EUROPEAN CONNECTION CONDITIONS

(ECC)

Figure 6.3.7.3.3(b) Active Power Frequency Response capability.

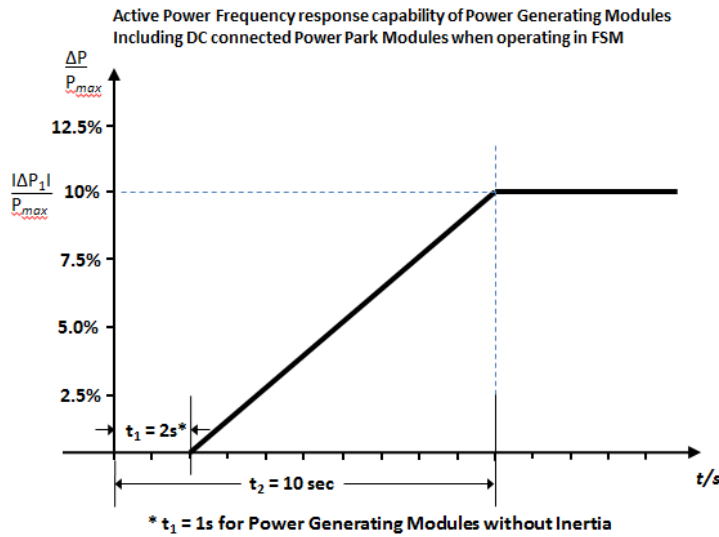
Commented [A20]: Diagram to be updated
